SUNDRY NOTICES AND REPORTS ON WELLS

San Juan 29-7 Unit 550S

HILCORP ENERGY COMPANY
SAN JUAN 29-7 UNIT 550S
MESA VERDE RECOMPLETION SUNDRY

Attachment to notice of Intent to Recomplete & Commingle

Well Name: SAN JUAN 29-7 UNIT #550S

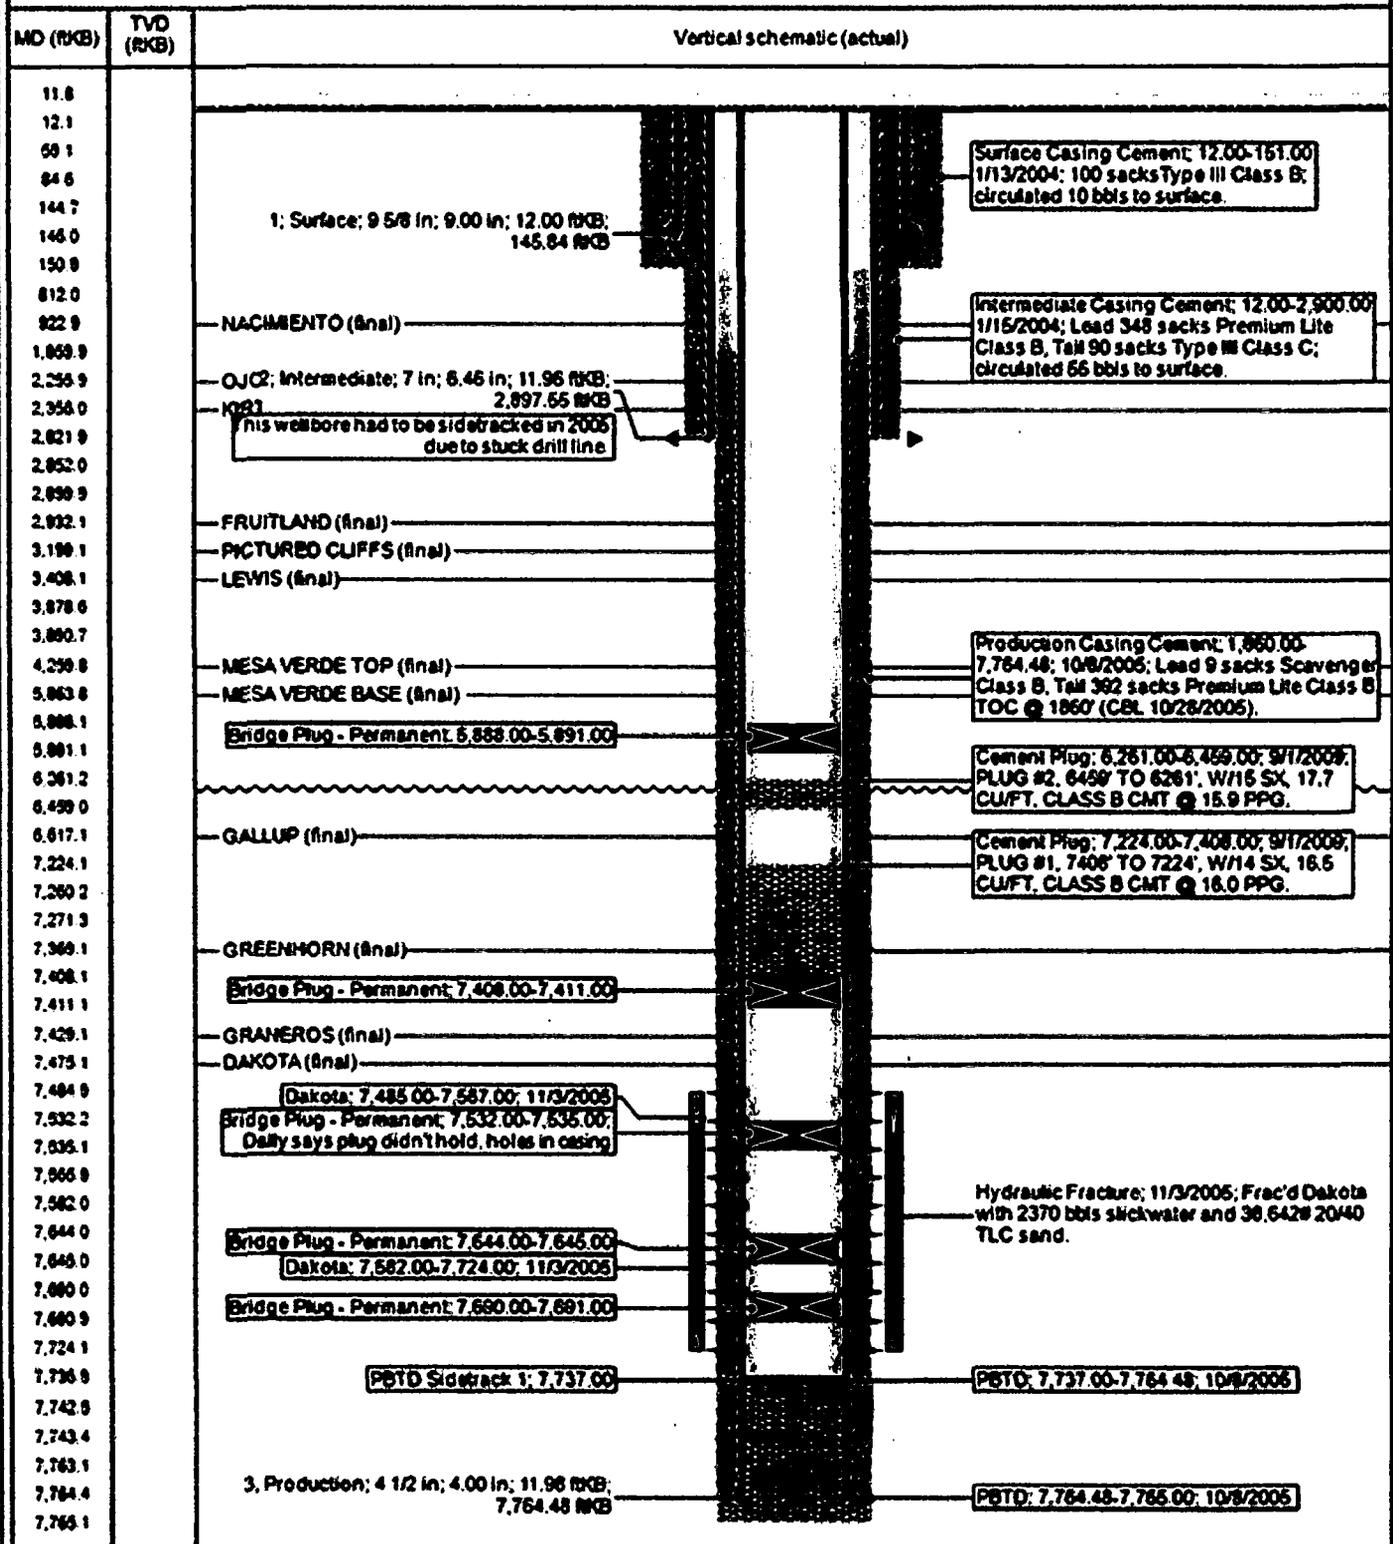
2. The following modifications to your recompletion program are to be made:

- a) Upon rigging up, record Bradenhead pressure and monitor same during recompletion operations. Notify BLM and NMOCD if anomalous pressure changes occur. Provide monitoring results in the subsequent Report of Operations.
- b) Casing pressure test for fracture stimulation operations cannot exceed the internal yield strength of the casing including a 20% safety factor unless a waiver is granted. Stimulation operations cannot exceed this test pressure.
- c) CIBP for base of fracture stimulation to be set less 50' above top existing perforation.
